MEMORANDUM FOR RECORD

May 10, 2012

**SUBJECT:** DREDGE PRISM MODIFICATION AND VOLUME REVISION FOR NAVAL AIR STATION (NAS) WHIDBEY ISLAND FUEL PIER (NWS-2011-1028), ISLAND COUNTY, WASHINGTON, FOR UNCONFINED OPEN-WATER DISPOSAL AT A DMMP NON-DISPERSIVE DISPOSAL SITE.

Figure 2 – Original Footprint and Sample Locations, NAS Whidbey Fuel Pier

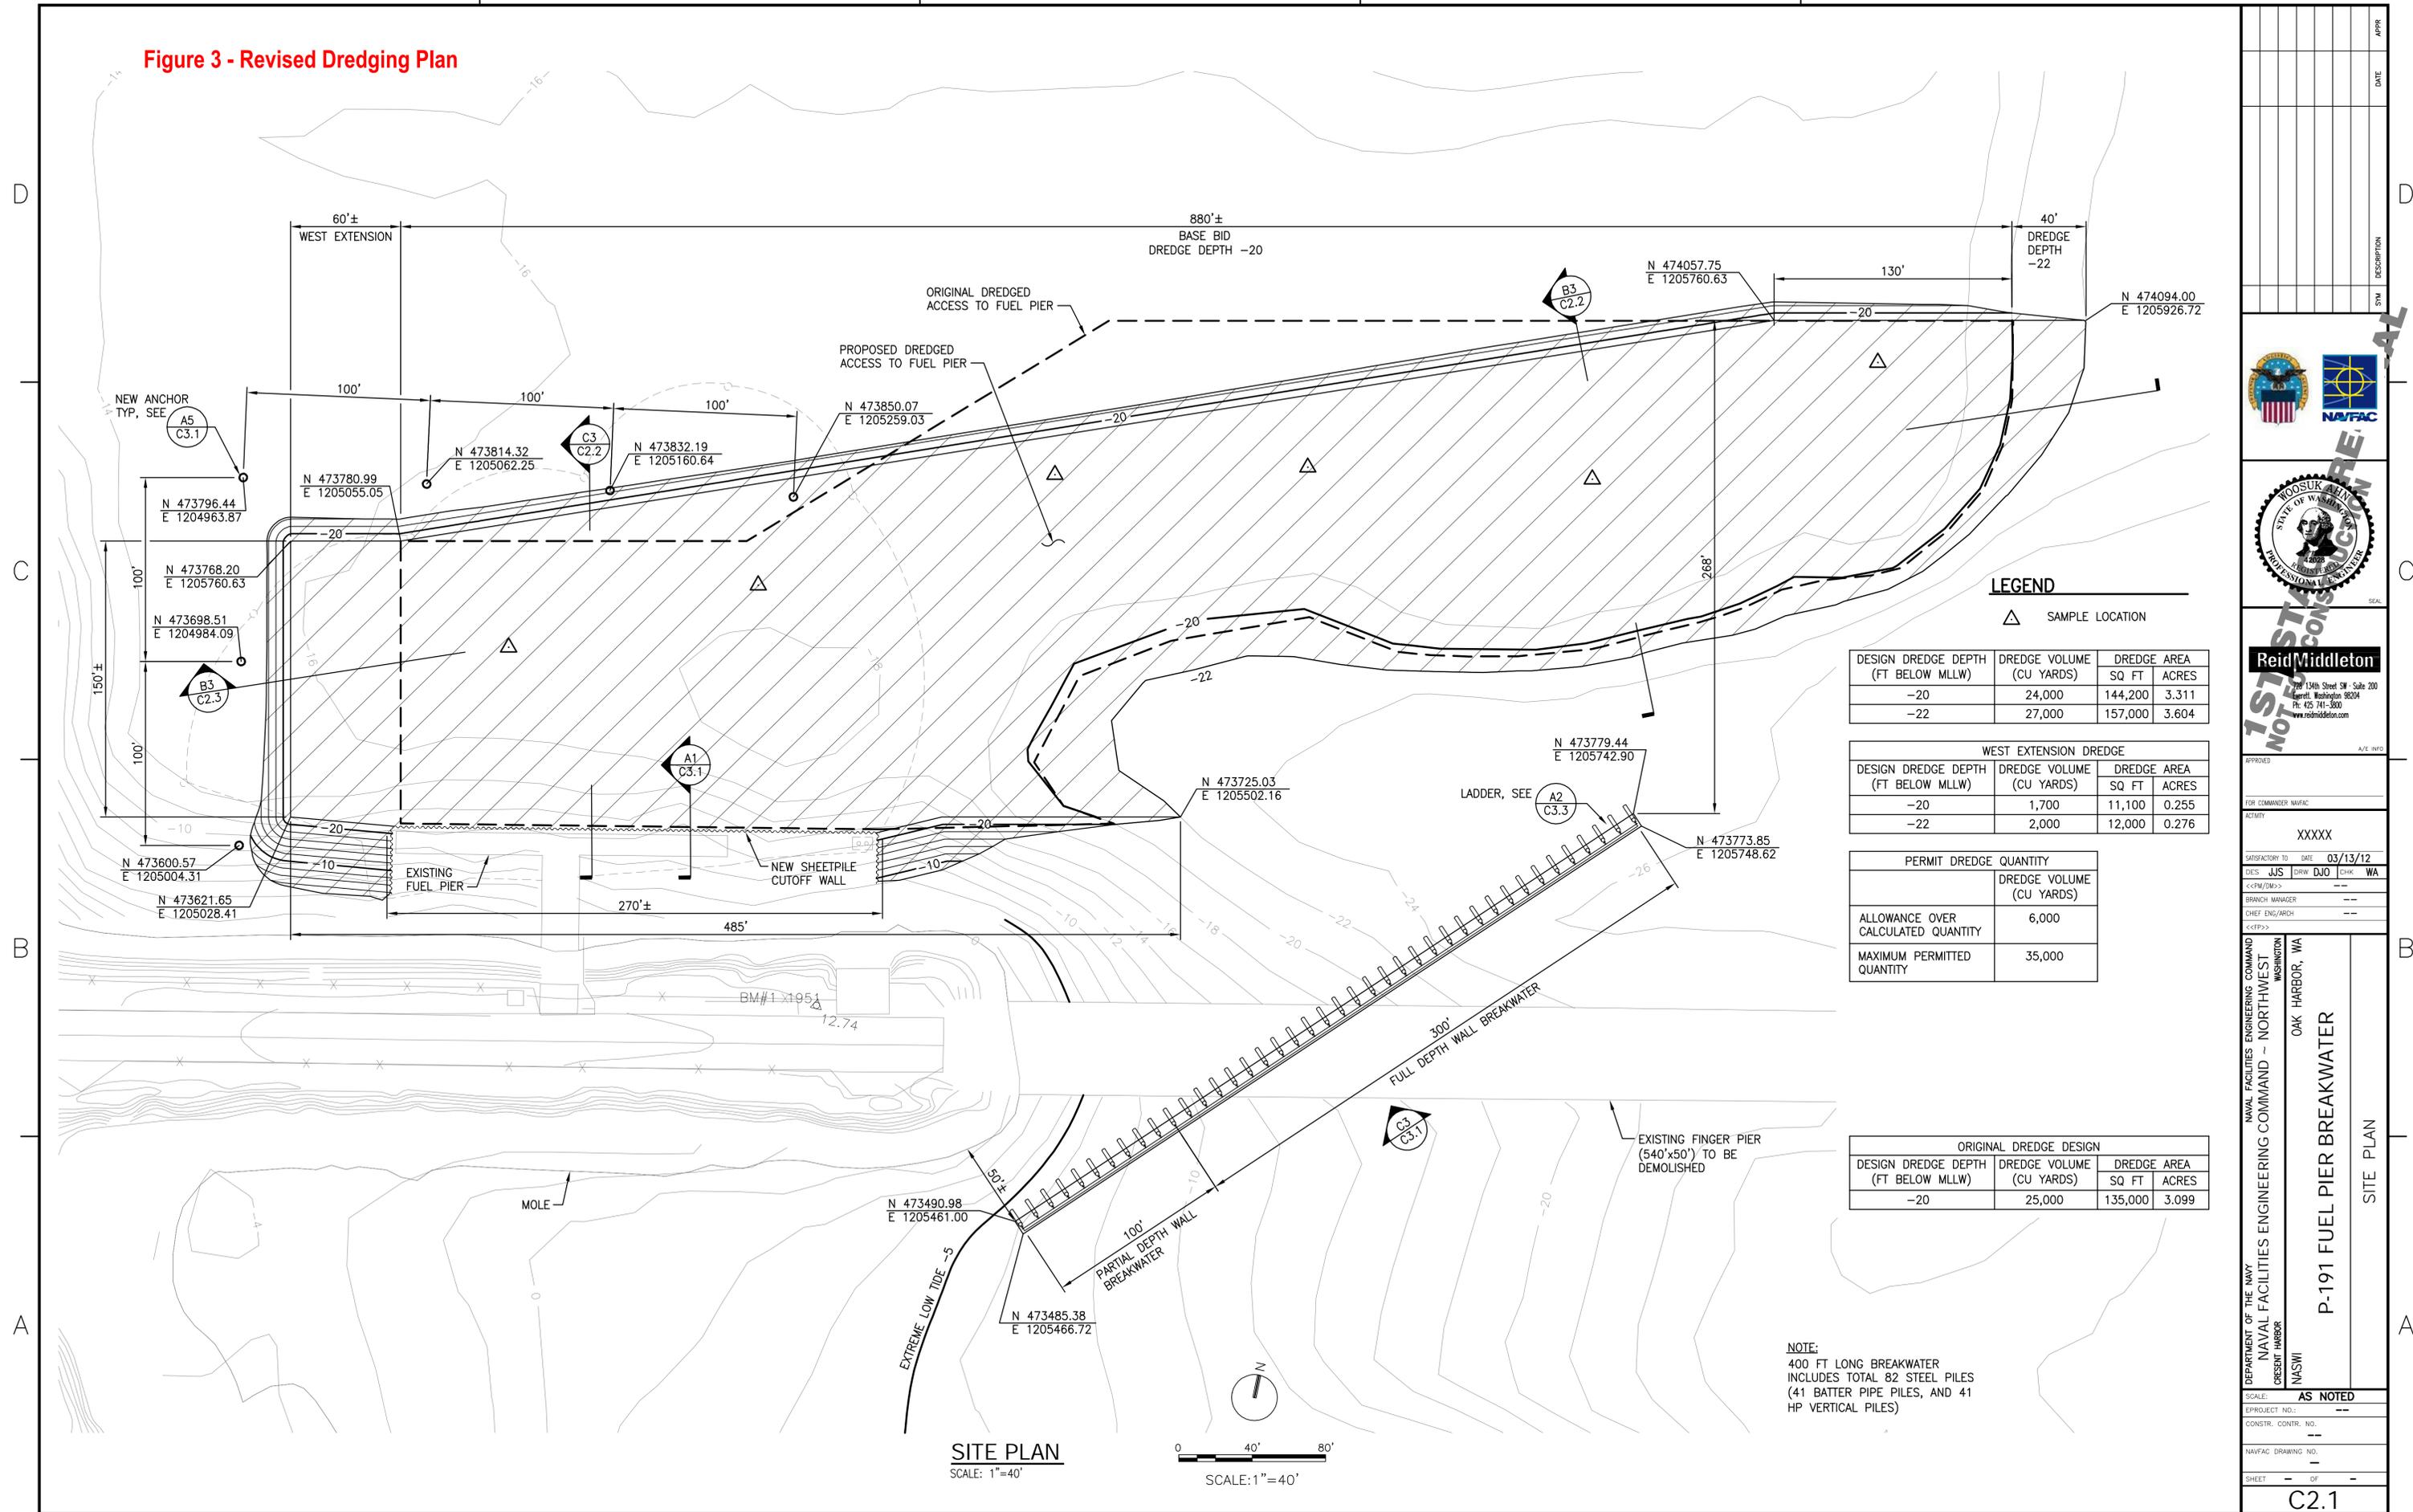
2. Subsequent to the 20 May 2011 suitability determination, the Navy made revisions to the project design. Figure 2 shows the footprint of the original dredging plan and the six sampling stations used in the DMMP characterization of the project. Figure 3 shows the modified design. For reference, Figure 3 also includes the footprint of the original design and the six DMMP sampling stations. As can be seen, the modified design includes minor changes in the footprint of the project, plus a 60-foot extension on the west end of the project. The design depth may also change. The original design depth was -20 feet MLLW (plus 1-foot of overdredge depth), but the Navy would like to include a bid option for an additional two feet of dredging for a revised design depth of -22 feet (plus 1-foot of overdepth). To cover this contingency the Navy has requested a volume increase to a maximum of 35,000 cy.

- The sampling stations used in the 2011 DMMP characterization fall within the footprint of the modified project and provide adequate spatial representation of the modified project.
